Work Order ID 145771

Item ID: D412-704-045 Accept ***N900040100*** Setup Start ***NS1***
 Revision ID: Stop ***NS2***
 Item Name: Cable Ass'Y
 Start Date: 4/28/2016 Start Qty: 5.00 ***5*** Cust Item ID:
 Required Date: 5/5/2016 Req'd Qty: 5.00 ***5*** Customer:
 Reference:

DART SERVICE INSTRUCTION

TO AMEND IIN-D412-704 REV. C OR EARLIER
AND ICA-D412-704 REV. 4 OR EARLIER
REF CANADIAN STC SH93-34
REF FAA STC SR00957NY
REF EASA STC EASA.IM.R.00696

Figure 5 - Detail L or Figure 25-4 - Detail L

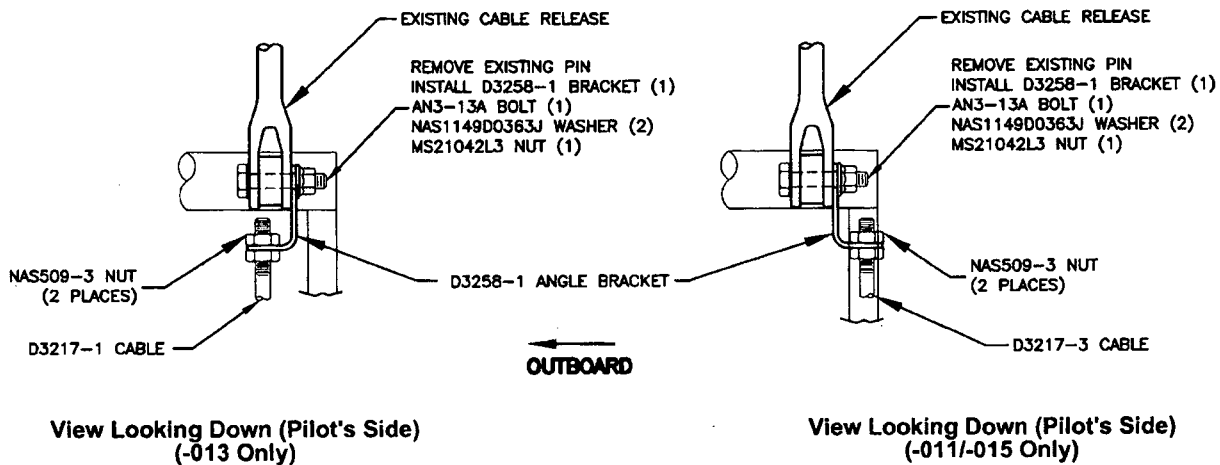
The purpose of this Dart Service Instruction is to correct part number error in Installations Instruction IIN-D412-704 Rev. C or earlier and Instructions for Continued Airworthiness ICA-D412-704 Rev. 4 or earlier. The AN3-13A bolt should be replaced with an AN3-10A bolt in Figure 5 - Detail L in IIN-D412-704 and Figure 25-4 Detail L in ICA-D412-704. See sheet 2.

Revise Detail L Figure 5 of IIN-D412-704 and Detail L Figure 25-4 of ICA-D412-704 as follows:

NOW

WAS
